NOTICE OF VIOLATION

Mallinckrodt US LLC/Medtronic

This Notice of Violation (NOV) is in reference to Mallinckrodt US LLC's (Mallinckrodt) ongoing failure to meet remediation requirements at its contaminated property that is subject to orders issued by the Department of Environmental Protection and the Board of Environmental Protection.

Plant Area CMI Plan, Concrete and Utility Removal, Addendum 4

Plant Area Site Plan of Approximate Locations of Visible Hg and Soil with Hg > MPS, Except the Former Cell Bldg Area, March 7, 2025

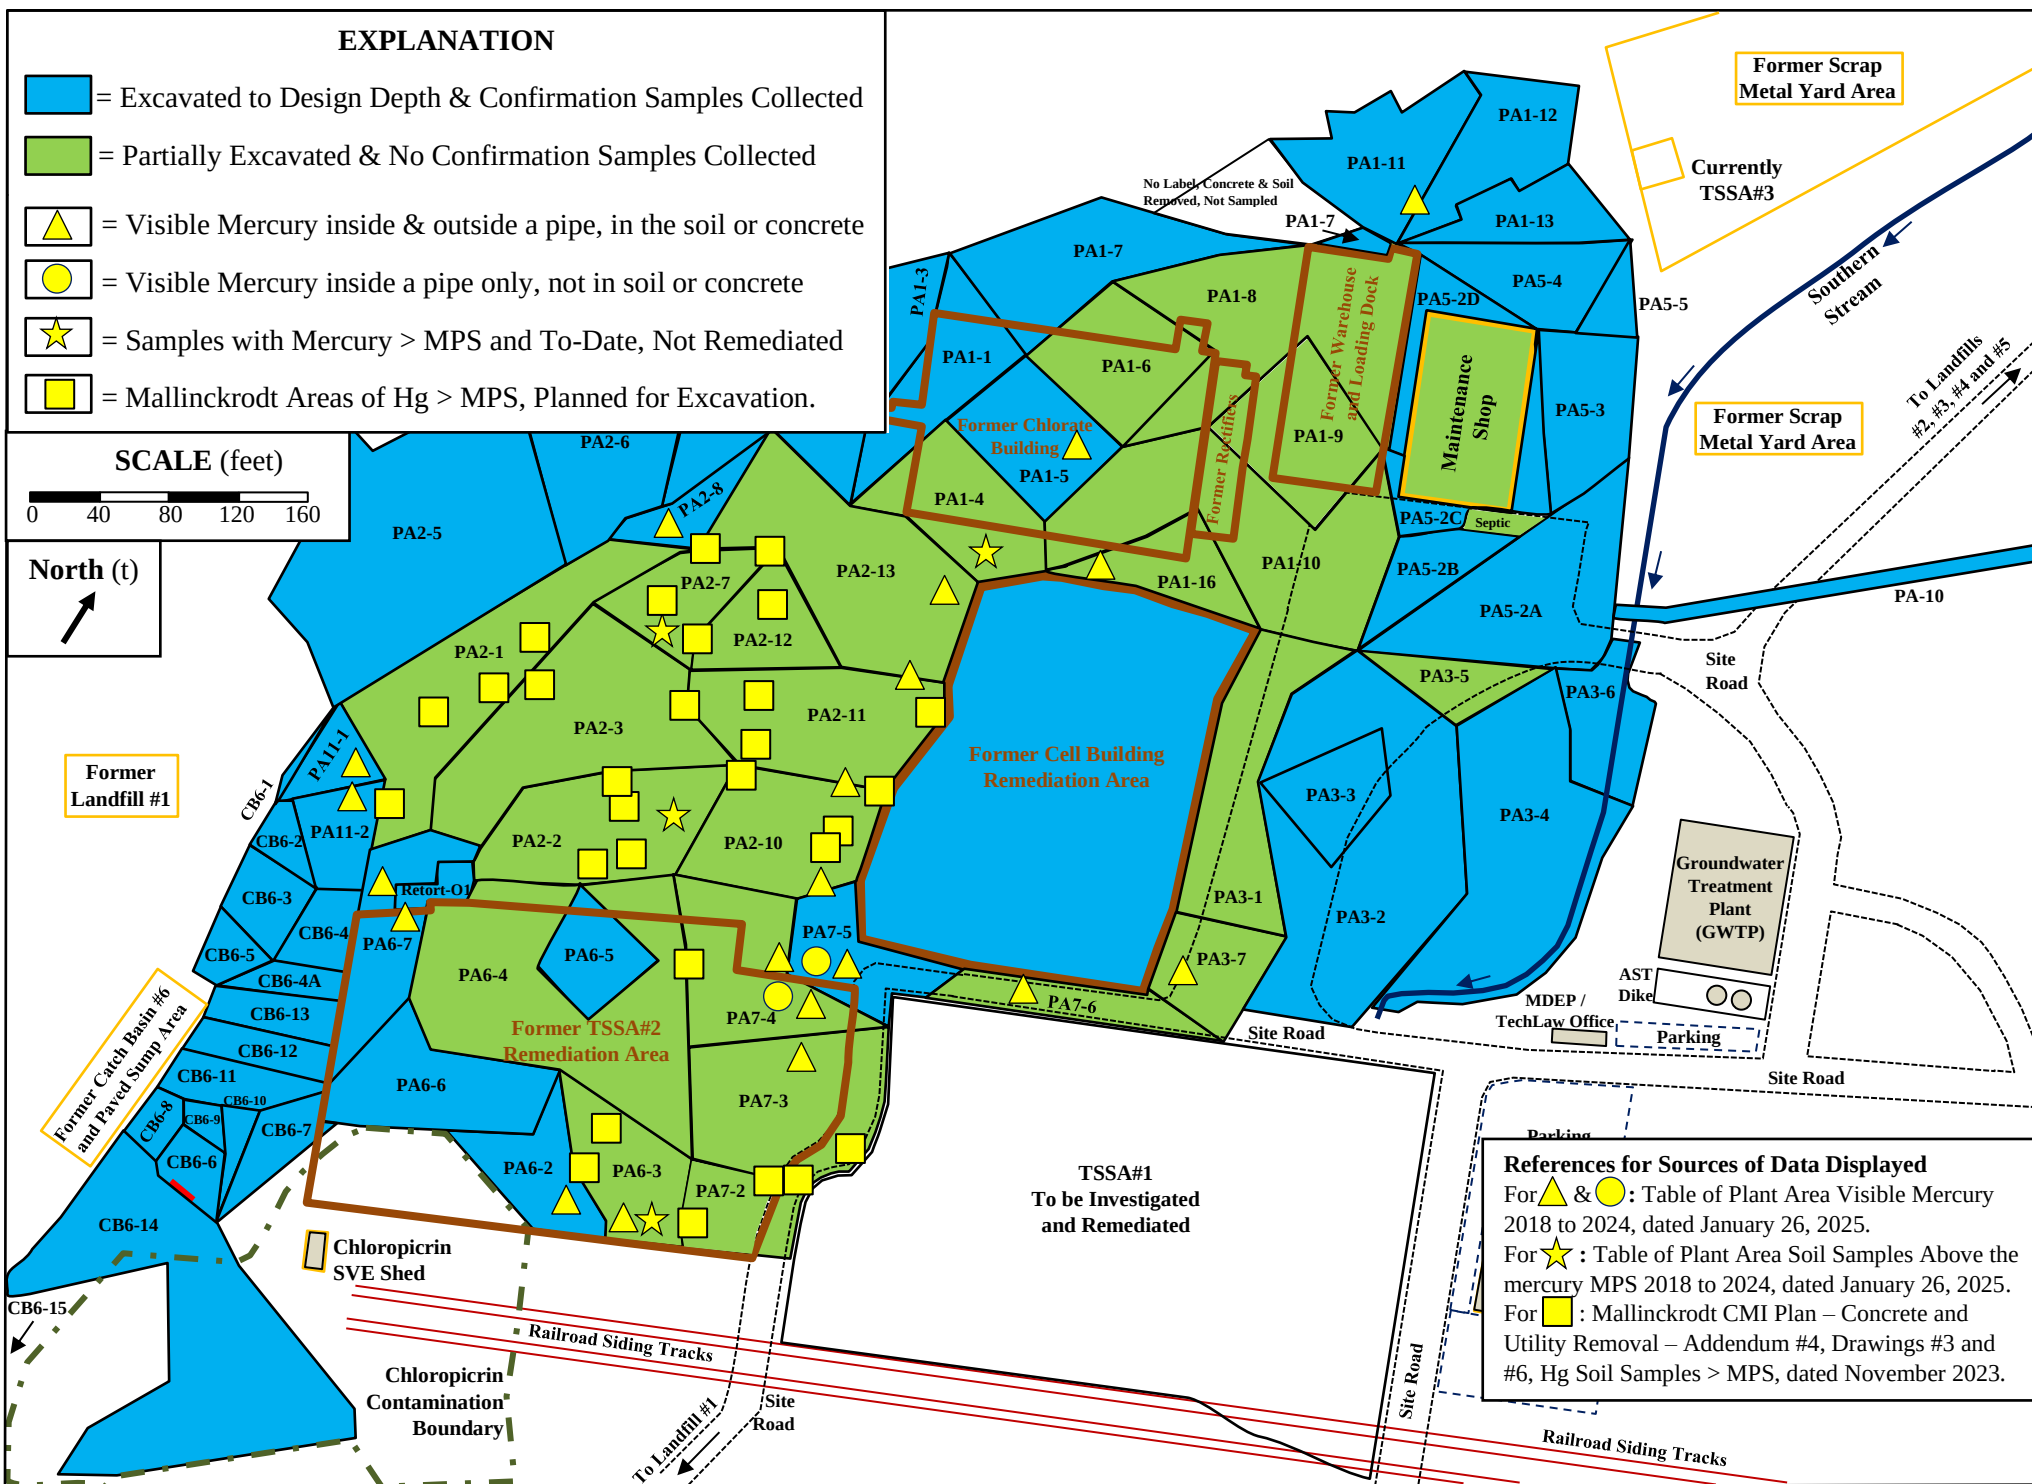
20. The DEP determined that Mallinckrodt's November 2, 2023, Plant Area CMIP was non-compliant with the DEP Orders and the DEP's June 2, 2023, letter because the Plant Area CMIP did not address remediation of all soils exceeding the mercury MPS at the Site, as required by the DEP Orders.¹³

21. Mallinckrodt's proposed November 2, 2023, Plant Area CMIP is inconsistent with the DEP Orders and departs from the DEP's approved remediation practices at the Site in several ways. Specifically, Mallinckrodt's proposed Plant Area CMIP artificially limits the locations where excavations would be performed by proposing to excavate small areas (20 ft X 20 ft) rather than entire cells as had been done with all previous excavations at the Site. The proposed Plant Area CMIP also limits the depth of excavation to no more than two feet below the depths of soil exceedances in boring samples, rather than continuing excavation until all sample results are less than the MPS of 2.2 ppm, as required by the DEP Orders and as has been done at all previous excavations at the Site other than Landfills 1 & 2. Mallinckrodt also proposes limiting excavations to a depth of 15 feet below ground surface, even though previous investigations and excavations have determined that soils exceeding the Site's MPS of 2.2 ppm for mercury have been found at greater depths in the Plant Area.

1. Within 30 days of receipt of this NOV, submit for the DEP's review and approval a detailed work plan to remove all solid material above the Site MPS from all unremediated areas within the Plant Area.
2. Within 15 days of receiving DEP approval or approval with modification, implement the approved plan.
